# Access Compliance Report

### (Curb Ramps)

| Intersection ID: 5544                   | Main Street: NORTHWOODS_FOREST_DR | Cross Street: SILVERBERRY_CT            | Location:              | N                    |
| ADA ID: 6F6D8EA17167                    | Ramp Type: Perp                   | Initial Pass/Fail: Fail                 | Overall Compliance: No | Severity Score: 12.5 |

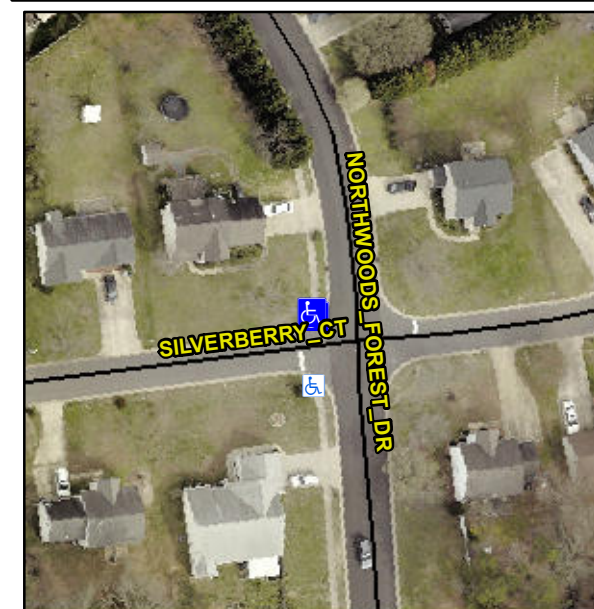
**Not Found, R304.5.3**

| Compliance | Description           | Data | Compliance | Description                 | Data |
|------------|-----------------------|------|------------|-----------------------------|------|
| Yes        | Ramp Width (in)       | 48.0 | No         | Ramp XSlope (%)             | 5.3  |

**Remove & Replace Entire Ramp.**
